JOINT REGIONAL PLANNING PANEL (Sydney East Region)

JRPP No	2015/SYE065
DA Number	LDA 2015/0156
Local Government Area	City of Ryde
Proposed Development	Demolition, construction of a part 3, part 6 and part 7 storey mixed use development containing retail and residential uses over 2 levels of basement car parking. A total of 3 retail premises and 56 residential units (as amended) are proposed
Street Address	142-154 Victoria Road & 1 Meriton Street, Gladesville
Applicant/Owner	Bridgelane Property 12 Pty Ltd
Number of Submissions	Four (4) submissions received
Regional Development Criteria (Schedule 4A of the Act)	General Development over \$20 Million
List of All Relevant s79C(1)(a) Matters	<ul style="list-style-type: none"> • Environmental Planning and Assessment Regulation 2000; • Environmental Planning and Assessment Act 1979; • State Environmental Planning Policy (State and Regional Development) 2011; • State Environmental Planning Policy No. 55 – Remediation of Land; • State Environmental Planning Policy (Building Sustainability Index: BASIX); • State Environmental Planning Policy No 65 – Design Quality of Residential Flat Development; • Draft State Environmental Planning Policy N

Figure 6: Proposed height non-compliance in comparison with approved neighbouring redevelopments (Source: DA drawing A-3009/02)

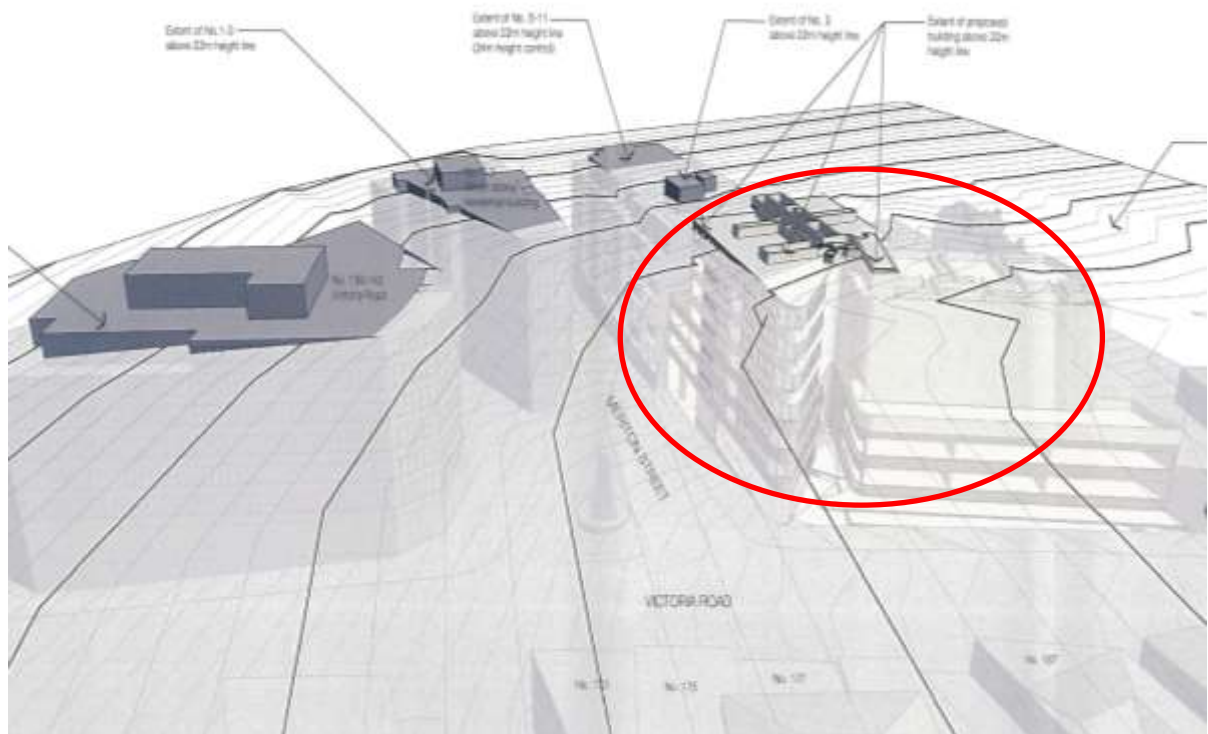
Whilst compliant on the Victoria Road frontage, the site slopes away to the south-west along the Meriton Street frontage. The proposed building consequently does not comply with the height control to varying degrees with the maximum breach extending to 2.37m measured at the south-eastern corner of the services core (RL 69.75). At the south-eastern corner of the top floor on the Meriton Street frontage (which is inset 7.6m from the side boundary), the breach extends to approximately 1m.

Figures 6 and 7 below illustrate the location and extent of the proposed height breaches. For comparison purposes, the **Figure 6** also illustrates the nature of breaches recently approved for neighbouring sites (the subject site is circled in red). **Figure 8** comprises the roof plan of the proposed development which allows comparison with **Figures 6 and 7** in terms of the roof elements that are in breach of the height control.

The variations to the height control of LEP 2014 are considered relatively minor and the development will still satisfy the objectives of the control and there are sufficient environmental planning grounds in this instance to justify contravening the development standard. Despite the non-compliance with the height control, the development satisfies the criteria outlined in clause 4.6 and the variation is acceptable and can be supported.

Figure 9: Current Key Site Diagram (site outlined in blue) including other sites forming part of the Wharf Road built Key Site (Source: SEE)

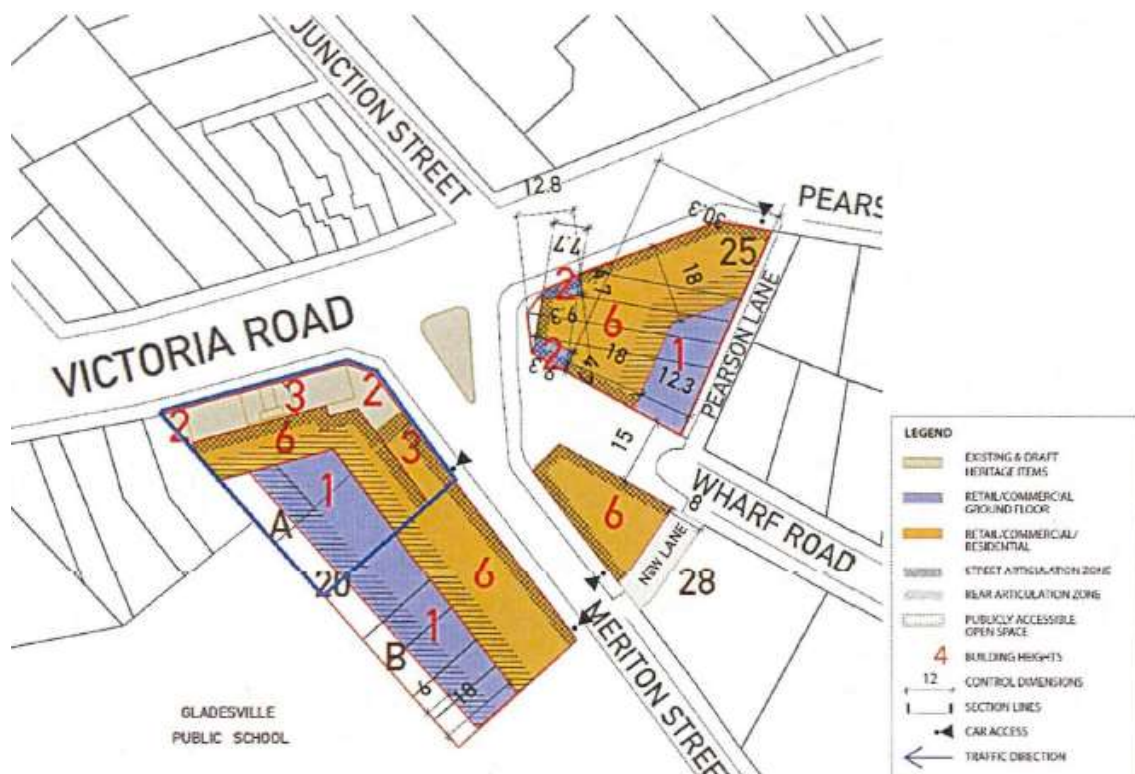
As noted in the table above, the subject site forms part of the Block 20, 25 & 28 (Wharf Road) Key Site diagram. The original and proposed Key Site Diagrams are shown below in **Figures 9** and **10** respectively:

A preliminary proposed amendment to the Key Site Diagram was reviewed by Council Officers and the UDRP in August 2013 at which time Officers confirmed demolition of the buildings on the site was potentially acceptable. A revised scheme was reviewed by the UDRP in November 2014 and it was agreed that the alternative built form proposed would potentially achieve an acceptable outcome for the site subject to design refinement at the DA stage. The UDRP have raised no objection to the proposed revised diagram submitted as part of the DA and the proposed built form has been suitably amended in accordance with comments received during the DA assessment.

Overall the revised Key Site Diagram is considered consistent with the objectives of the DCP and represents an appropriate redistribution of building bulk as originally anticipated for the site. The revised diagram is supported by the UDRP and Council Officers. This DA has therefore been assessed on the basis of the revised Key Site Diagram and the proposed development is considered consistent and acceptable in this regard.
